Clauses in RFP for Supply, Installation and Maintenance of Passive and Active Network Components at DC. Mumbai and DC. Hyderabad.

सूचना प्रौद्योगिकी विभाग, बीसीसी, मुंबई Information Technology Dept., BCC, Mumbai

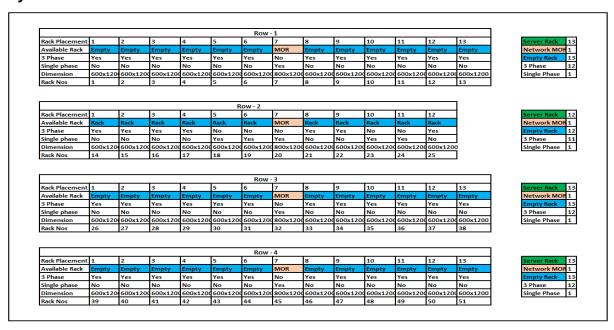
137	59	Mumbai Site	Rack layout	Bidder requests bank to reconfirm the count of 3 Phase and Single Phase to procure the right type of PDU . There seems to be some count mismatch in Row I	Please refer Revised Rack layout
138	59	Hyderbad Site	Rack layout	Bidder request bank to reconfirm the count of Server Racks as the count of Racks in layout and summary is not matching	The Extra rack no is for future expansion or existing replacement
139	60	Mumbai and Hyderabad Site	Rack count in scope and commercial template	Bider seeks clarity oin count of racks as there is a mismatch observed in the counts in Commercial template and Scope document (92 v/s 81)	The Extra rack no is for future expansion or existing replacement
140	61	Structured Cabling	Copper cable type	Please confirm if the copper cabnle is Cat 6A UTP or STP ?(Mention of STP in Page 64)	The Cable type will be UTP
141	74	Delivery Period	All the deliverables should be delivered within 6 weeks from the date of acceptance of purchase order by successful bidder	Bidder requests Bank for a timeline of 8-10 weeks from the date of Contract for Passive Cabling and 12 weeks for Active Components	Please refer addendum document
